RE: **Lot 7 Block 8 Unit 5 S.A.D. 227**
6201 Kayenta NW
Grading and Drainage Plan
Engineers Stamp Date 10/2/18 (E10D051)

<div>ENGINEER'S SEAL</div> <div></div> <div>10/2/18</div> <div>DAVID SOULE P.E. #14522</div>	6201 KENYENTA	DRAWN BY: WCMJ
	GRADING AND DRAINAGE PLAN	DATE: 10-02-18
	<div>Rio Grande Engineering 1606 CENTRAL AVENUE SE SUITE 201 ALBUQUERQUE, NM 87106 (505) 872-0399</div>	218144-LAYOUT-10-02-18
		SHEET #
		JOB # 218144

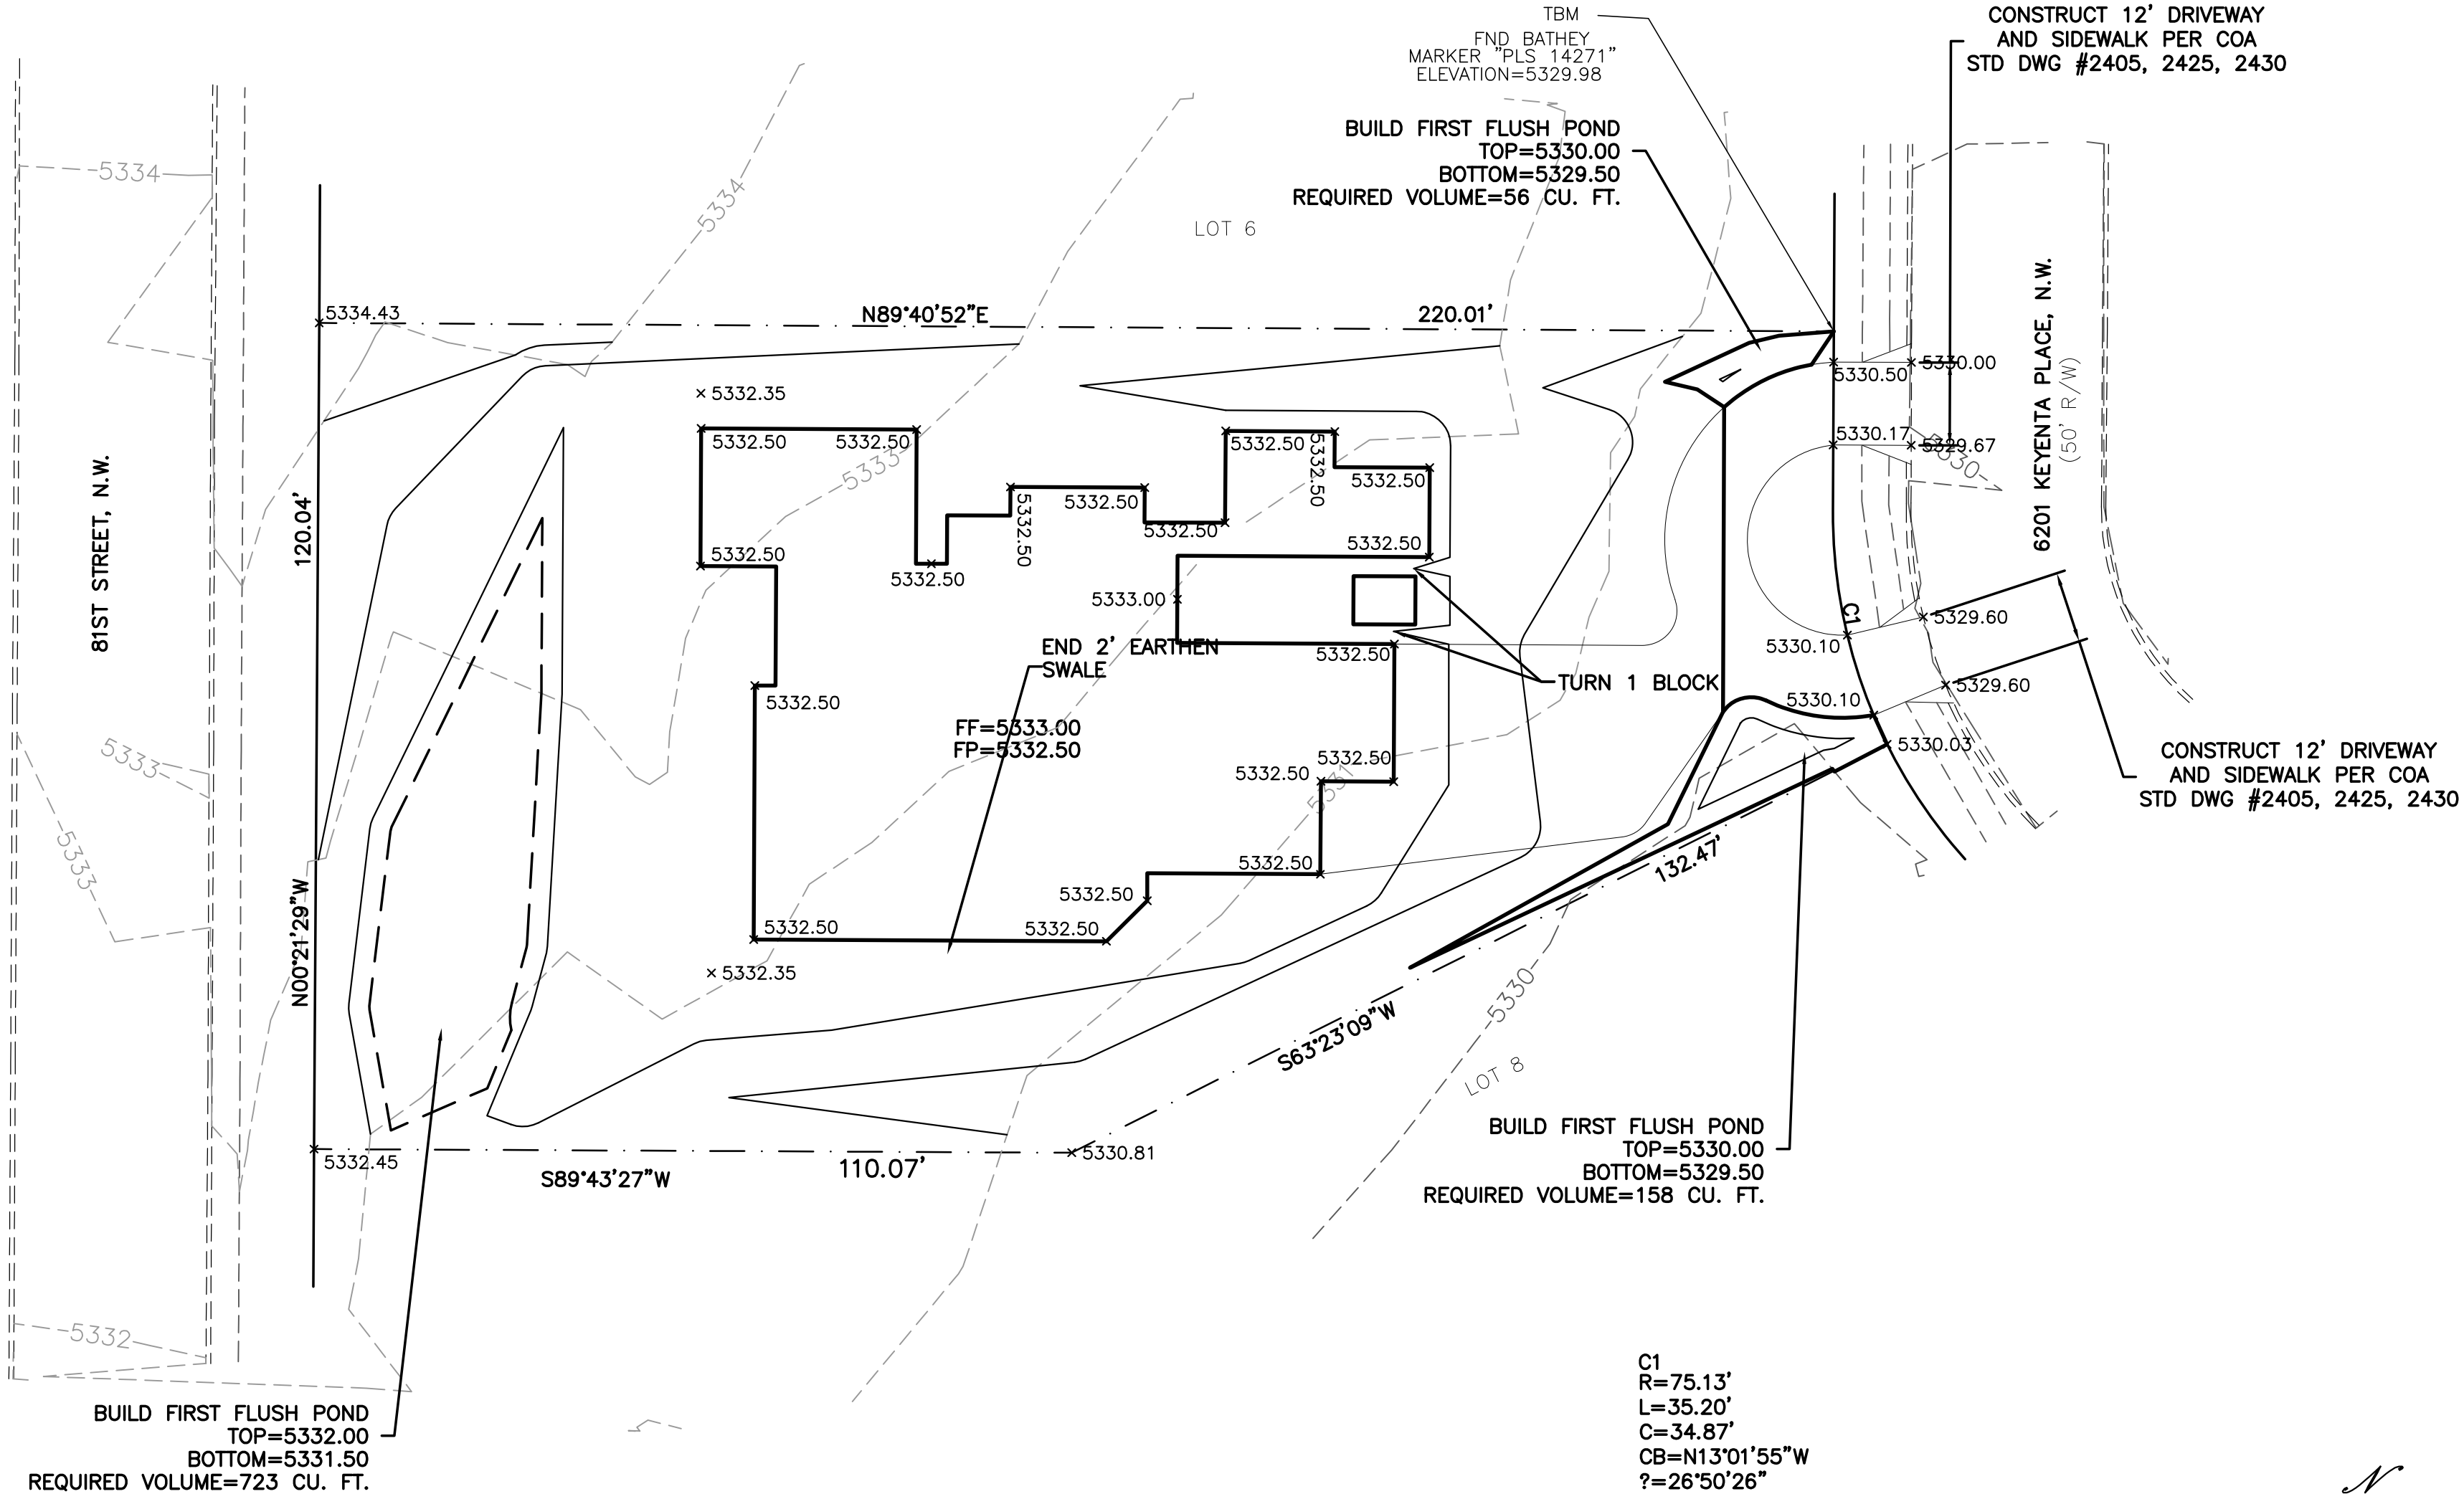
Based upon the information provided in your submittal received 10/3/18, this plan is approved for Grading Permit. Please inform the builder/owner to attach a copy of this approved plan and letter into the construction sets in the permitting process prior to sign-off by Hydrology.

Reiterate to the Owner/Contractor that a separate permit for any garden/retaining wall must be obtained, with the approved G&D plan.

Prior to Building Permit approval, a **Pad Certification** will be required.

Prior to **Certificate of Occupancy release**, Engineer Certification per the DPM checklist of this plan will be required.
